**CITY OF ISANTI  
PLANNING COMMISSION MEETING  
TUESDAY, February 15, 2022  
Immediately Following the 7:00pm City Council Meeting  
CITY HALL**

SUBJECT: Site Plan Review and CUP Approval for a Commercial building for Little North Boutique with a drive-thru located at 291 5<sup>th</sup> Ave NE

**Date:** February 7, 2022  
**To:** Stephanie Hillesheim, Community Development Director  
**From:** Jason W Cook, P.E.  
City Engineer  
**Subject:** Little North Boutique - Plan Set - Engineering Review  
City of Isanti, MN  
Project No.: 0R1.123130

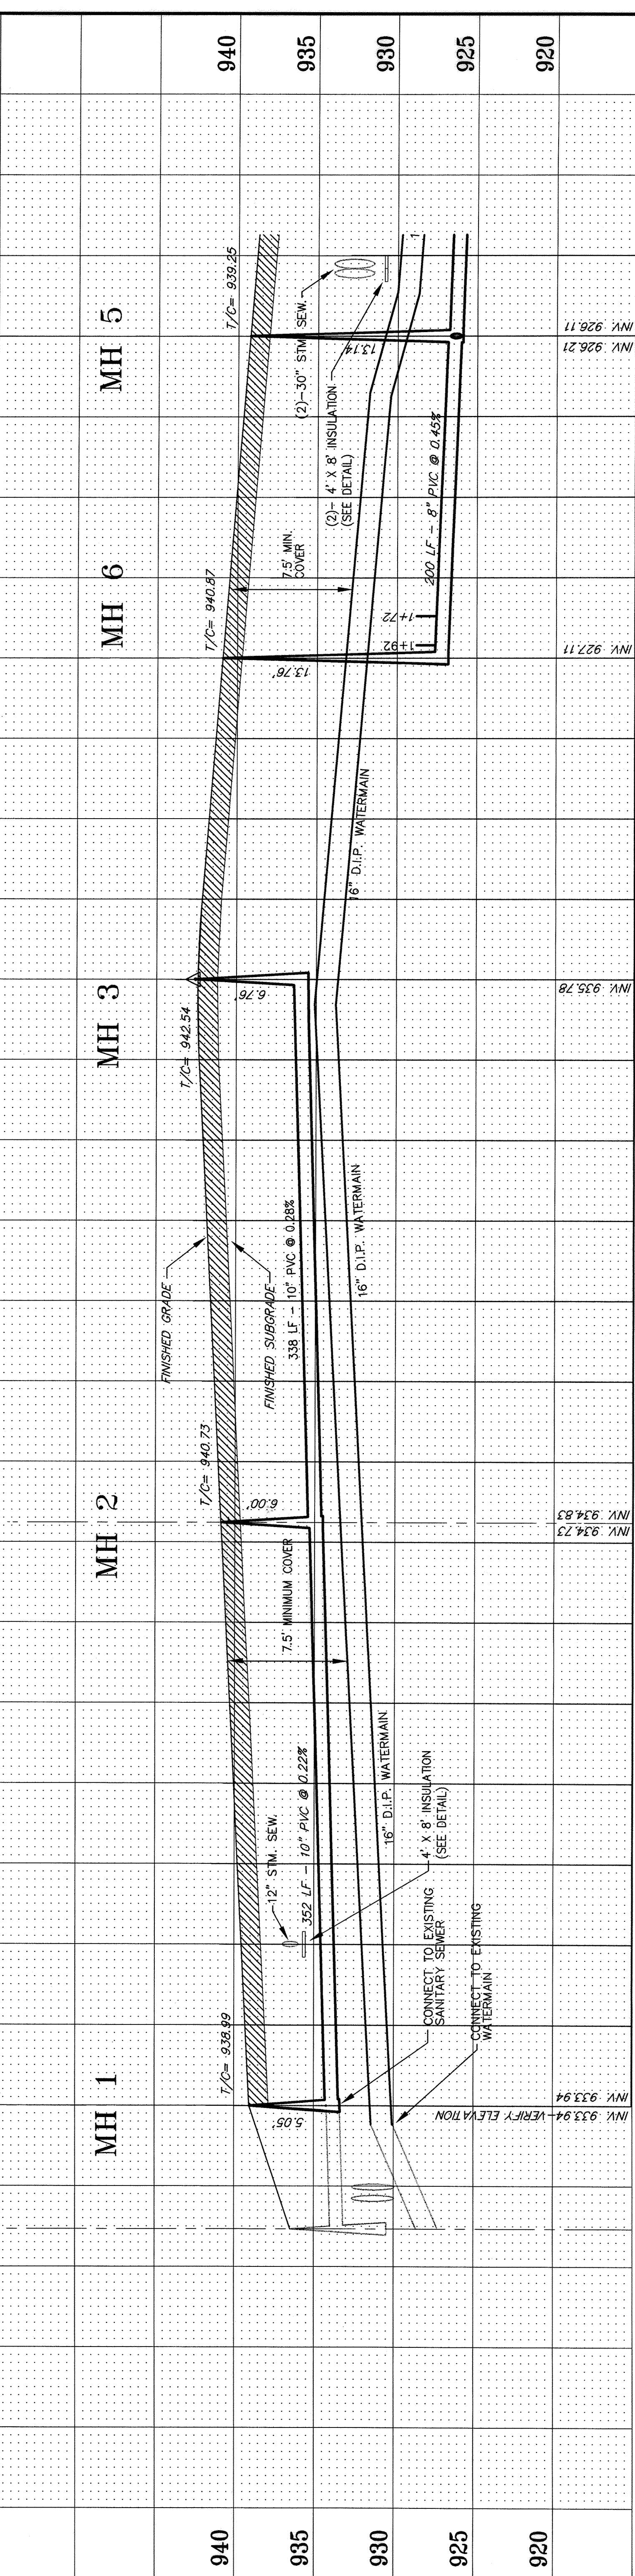
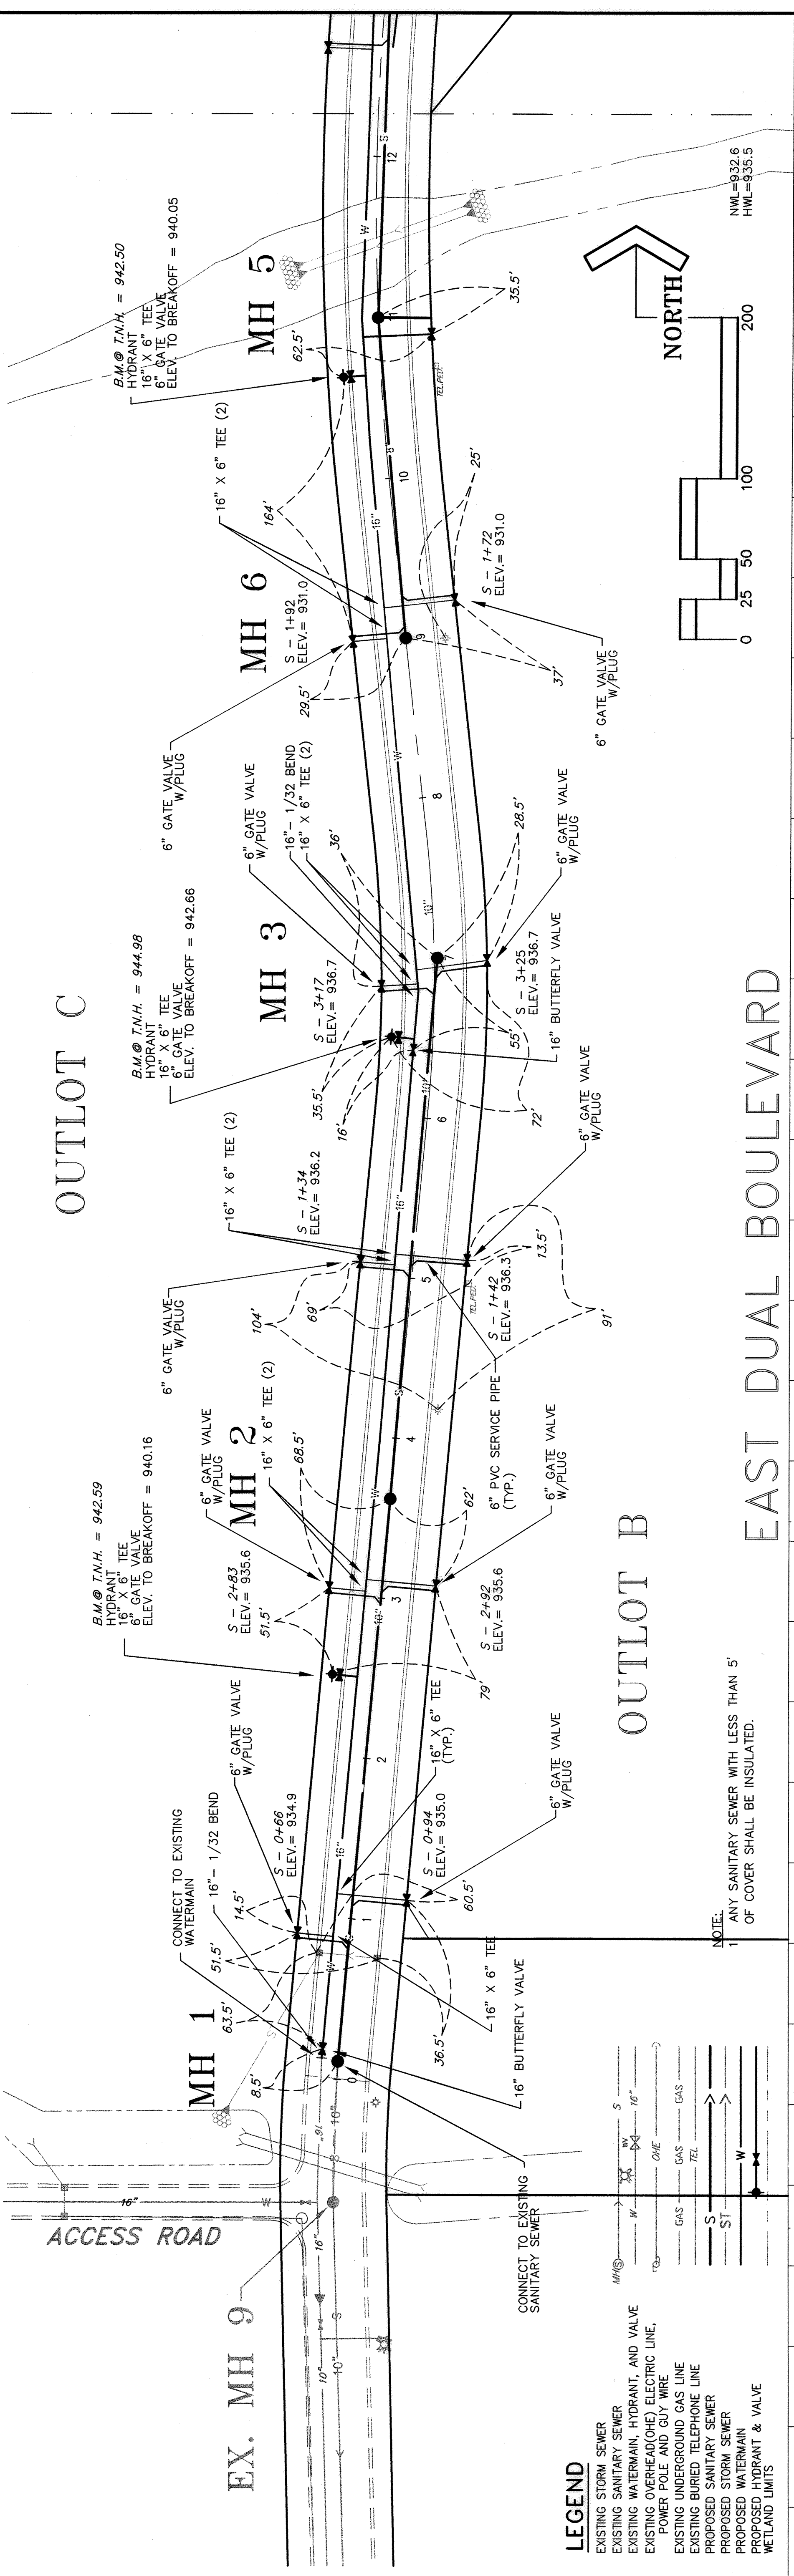
1. Use existing sanitary sewer stub to avoid cutting into street. See attached record drawing. Verify depths and adjust site accordingly.
